RE: Parker & Pine Filing No. 1 Lot 2 – Site Plan – SP20-019

Please find below our comment responses addressing the first submittal for the Site Plan comments for the proposed Murphy Oil. This letter is to address comments we received from you on May 6, 2020. To facilitate your review, we have included the original conditions in *italicized* font and have provided our responses in **bold blue**.

FIRE MOBILITY PLAN  
 MURPHY EXPRESS  
 12405 SOUTH PARKER ROAD  
 PARKER COLORADO

SHEET NO. C-1.2

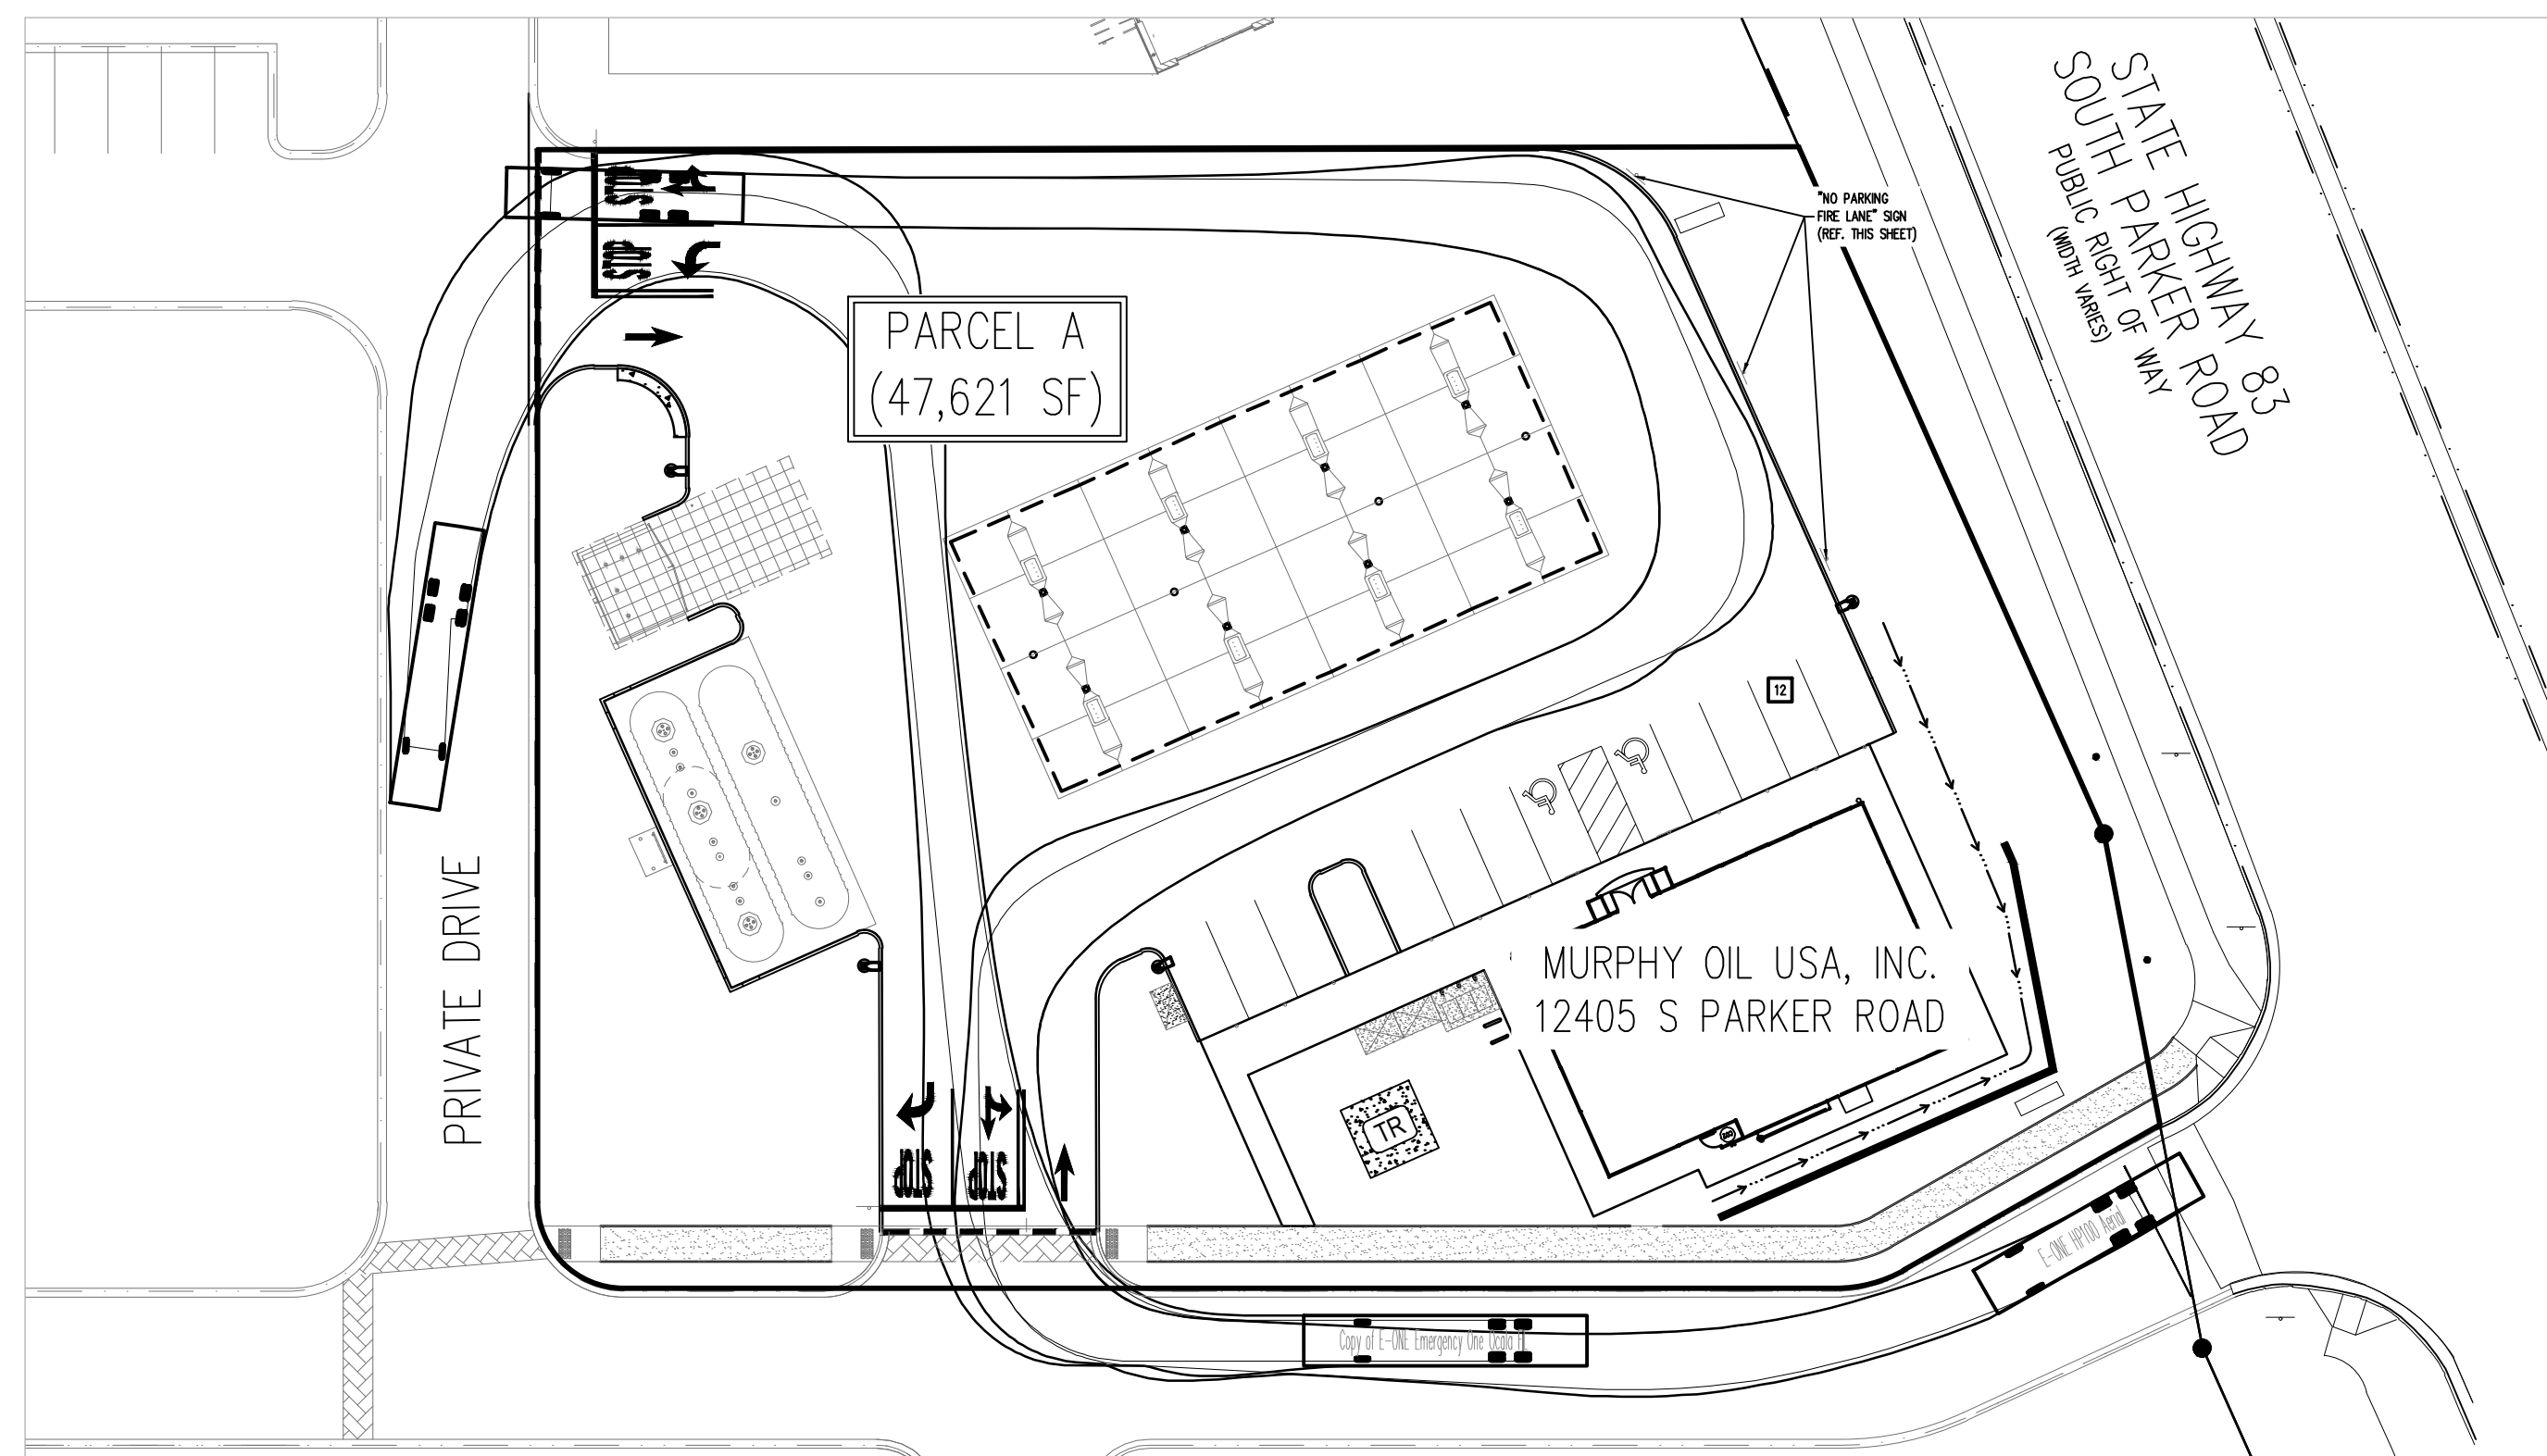
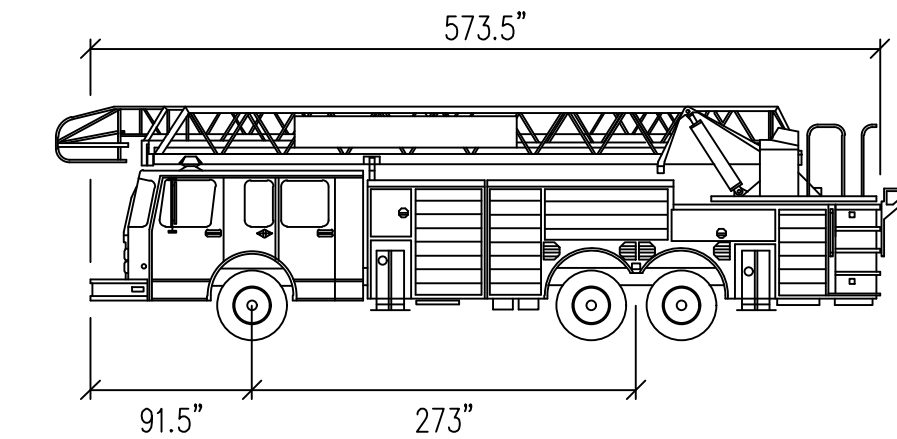
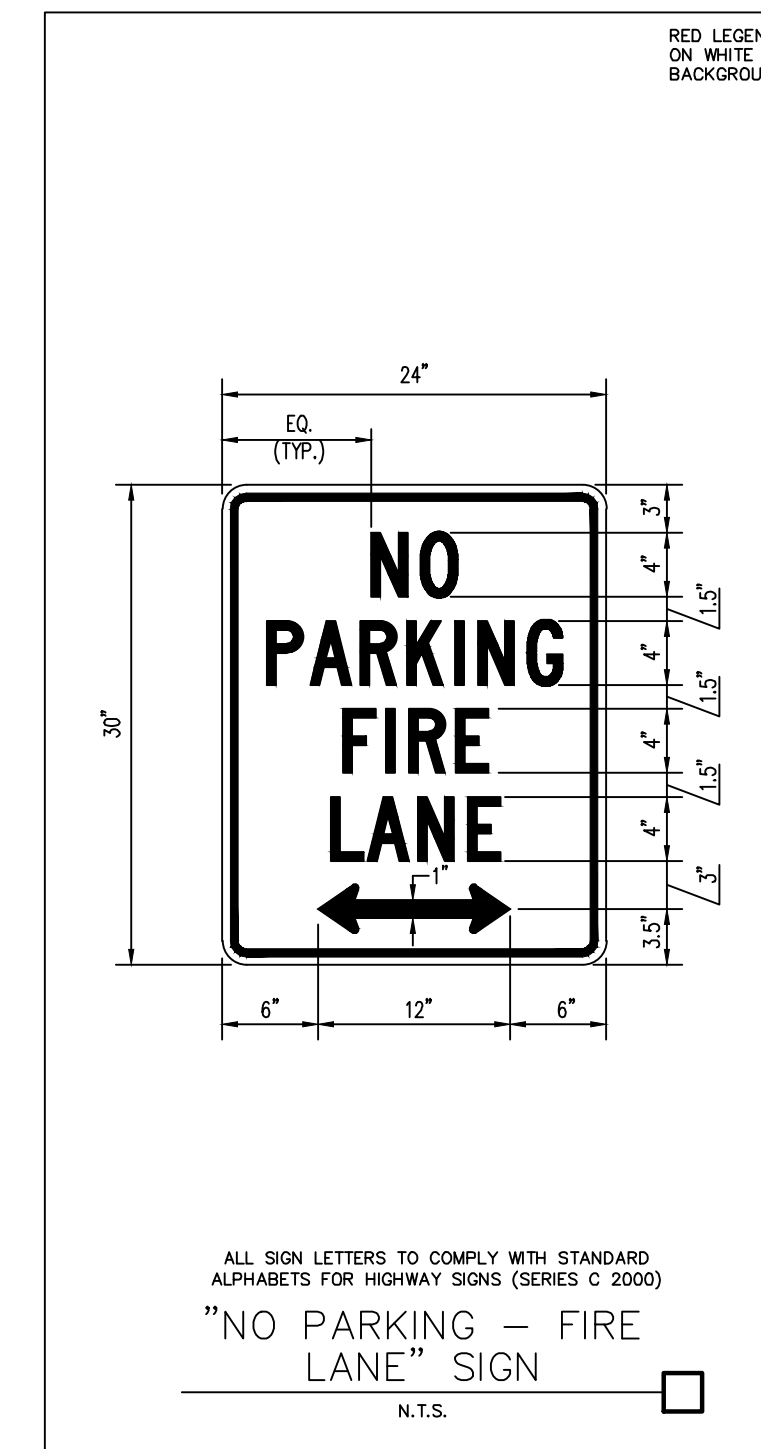
3. The applicant shall provide an auto turn analysis indicating that apparatus can navigate all portions of this site (both sides of the gas canopy); NO PARKING – FIRE LANE signage is required for any portion of the access where the 20-foot clear width requirement cannot be met. This is applicable for the loop around the canopy as well as for each entry. The access on each side of the canopy shall meet his requirement with no portion of the canopy encroaching into the required fire lane access road. *Partially satisfied; applicant has addressed with current submittal. Note – the applicant has provided a Fire Life Safety signature block on the sheet C-1.2 (Fire Mobility Plan); the applicant shall be aware that Fire Life Safety will only sign the signature block on the two sheets specified for the utility drawings. This signature block should be removed.*

**Response:** The signature block has been removed from the Fire Mobility Plan. A fire access mobility plan showing the fire apparatus turning analysis has been included at the end of this letter. “NO PARKING – FIRE LANE” signs have been added to the areas where parked vehicles could potentially encroach into the required 20-foot clear width.

**Response:** The drive aisle to the west of the canopy and in between the canopy and the c-store have an unimpeded clear width of over 20 feet. On the opposite side of the drive aisle from the canopy on the east and north sides, “NO PARKING – FIRE LANE” signage has been added to maintain the 20 feet. The pavement specifications have been designed to withstand the imposed weight of the fire apparatus, 30 two axle and 40 ton three axle vehicles, please reference the email from the geotechnical consultant at the end of this letter.
